### APPEAL SUMMARY

<b>Appeal ID:</b> 21868	<b>Project Address:</b> 2256 NW Overton St
<b>Hearing Date:</b> 9/11/19	<b>Appellant Name:</b> Jason Ferrier
<b>Case No.:</b> B-020	<b>Appellant Phone:</b> 360-844-6002
<b>Appeal Type:</b> Building	<b>Plans Examiner/Inspector:</b> Tara Carlson
<b>Project Type:</b> commercial	<b>Stories:</b> 3 <b>Occupancy:</b> R-2 <b>Construction Type:</b> V-B
<b>Building/Business Name:</b> Overton condo	<b>Fire Sprinklers:</b> Yes - proposed basement renovation
<b>Appeal Involves:</b> Alteration of an existing structure, occ Change from S2 to R2	<b>LUR or Permit Application No.:</b> 18-165495-CO
<b>Plan Submitted Option:</b> pdf [File 1] [File 2]	<b>Proposed use:</b> Residentail apt rental

# OVERTON CONDO REMODEL

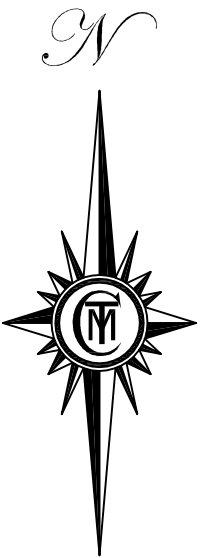
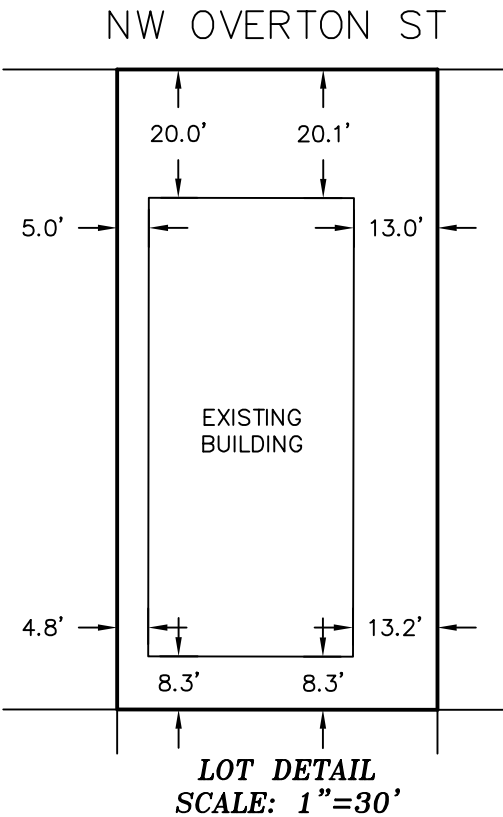
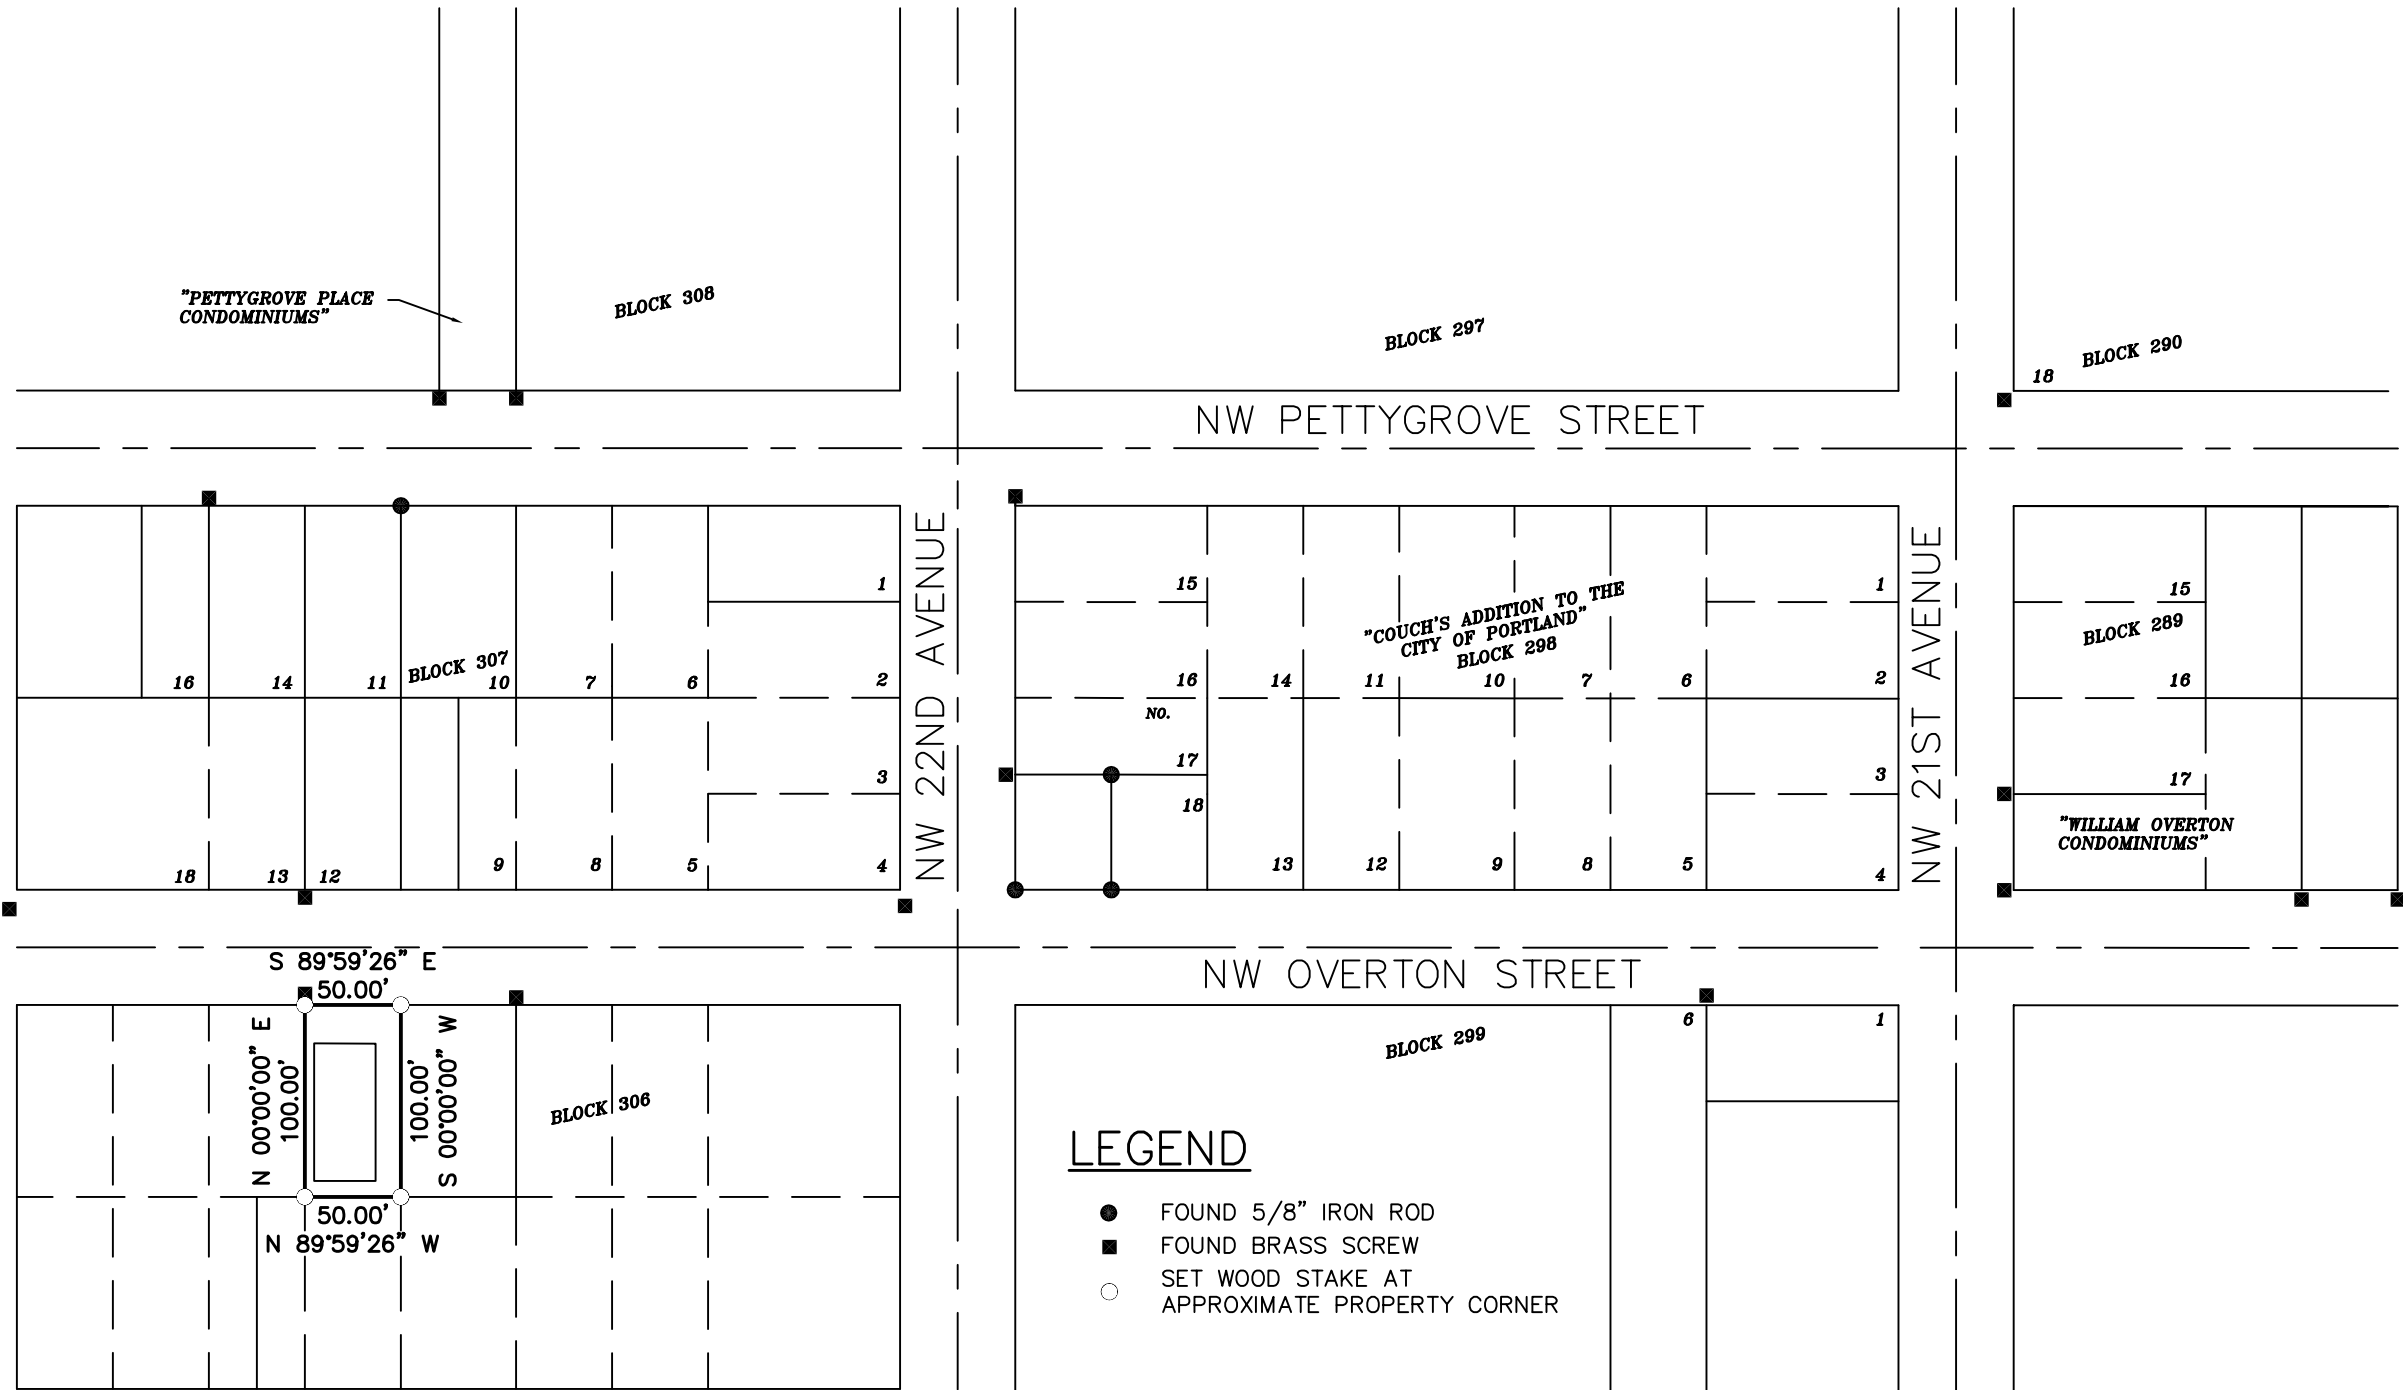
**Code Section** 705.8

<b>Requires</b>	Per section 705.8 Openings, Table 705.8, the allowable area of openings with a fire separation distance of between 3' to 5', if sprinklered, is 15%. The allowable area of openings with a fire separation distance of between 5' to 10' is 25% if sprinklered. The existing elevation with additional req'd egress windows for bedrooms totals 22% of the ground floor wall area.
<b>Proposed Design</b>	The surveyed lot shows the fire separation distance (FSD) or property line angling at 4.8' to 5' from the existing building which is just 2-1/2" short of the 5' mark which would allow up to 25% openings. The entire basement of the existing structure will be sprinklered, which would only allow 15% openings, as it exists under a strict interpretation of the code. The basement wall is concrete to the 1st floor, so is currently a 1 hour rating.
<b>Reason for alternative</b>	Removing windows to reach the 15% allowable openings would result in an apartment with very little daylight and natural ventilation and would create poor living conditions for potential residents. The nearest building that exists on the lot west of the FSD is approximately 55' away from the FSD/prop line in question. There is a concrete driveway serving this building in place between the neighboring building and the FSD/prop line, so future development towards the subject property is not likely. At 22% coverage the opening percentage is below the max allowed. Considering 15% coverage would be allowed at 3' and 25% at 5', extrapolating for 22% coverage would give you 4.4' which is less than what currently exists.

**Increase in exterior wall openings at property line where openings are not allowed: Denied. Proposal does not provide equivalent Life Safety protection.**
